**THFC Hotel S73 Application – Wind Microclimate Review**

**Northumberland Development Project – Section 73 Application  
Wind Microclimate ES Addendum Review**

Figure 8 – Balconies, CFD predictions of worst-seasonal comfort

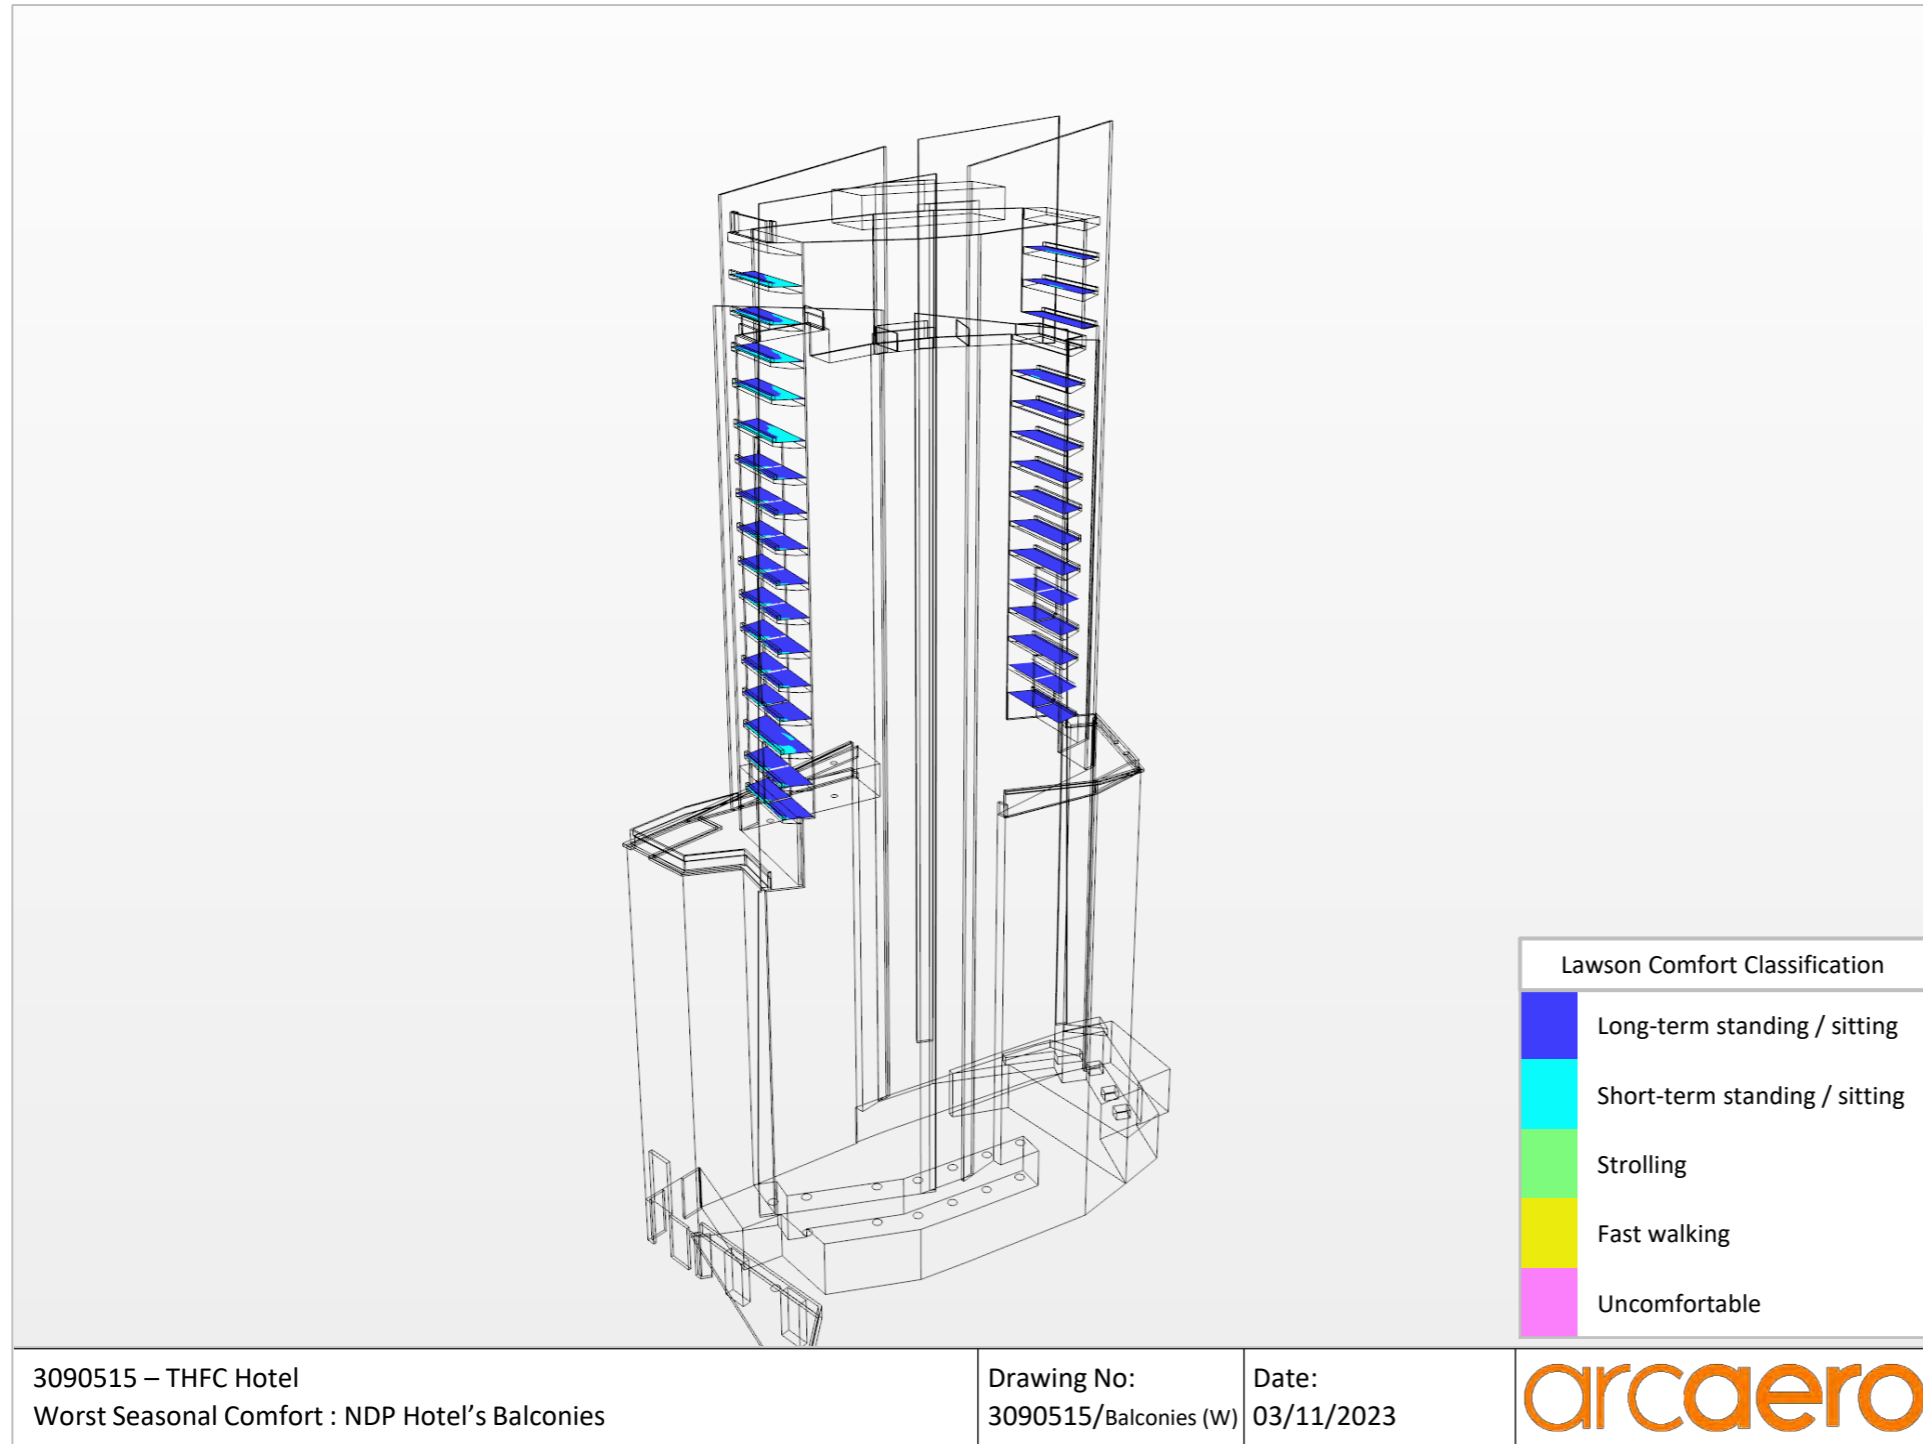
The ES chapter indicates that the recessed balconies within the residential component of the proposed Hotel have been assessed through Computational Fluid Dynamics (CFD). Given the level of shelter to the balconies, the conclusion of acceptable conditions is considered plausible. However, **it is recommended that further details on the CFD studies and results be requested from the applicant.**

<p>The ES chapter indicates that the recessed balconies within the residential component of the proposed Hotel have been assessed through Computational Fluid Dynamics (CFD). Given the level of shelter to the balconies, the conclusion of acceptable conditions is considered plausible. However, it is recommended that further details on the CFD studies and results be requested from the applicant.</p>		<p>Please see Figure 8 for predictions of worst-seasonal balcony comfort. Balconies are predicted to be substantially suitable for long-term sitting year-round, suitable for at least short-term sitting year-round, and correspondingly suitable for long-term sitting during summer.</p>
<p>The presented results suggest that further potential impacts to the west and south of the Site are unlikely, though the potential effects on the operations of The Dare Skywalk are less obvious. It is therefore recommended that the likely effects at the additional receptors listed in the previous section are confirmed by applicant.</p>	<p>The Dare Skywalk</p>	<p>Please see Figure 3 that presents summertime CFD comfort contours for the Dare Skywalk with the complete NDP development in place.</p> <p>As Figure 3 indicates conditions around the Dare Skywalk are predicted to be substantially suitable for strolling in summer upon introduction of the development, including the Plot 3 hotel, with the region suitable for fast-walking reduced in size.</p> <p>This represents a marginal improvement to conditions following the introduction of the completed development, and thus a minor beneficial effect.</p>
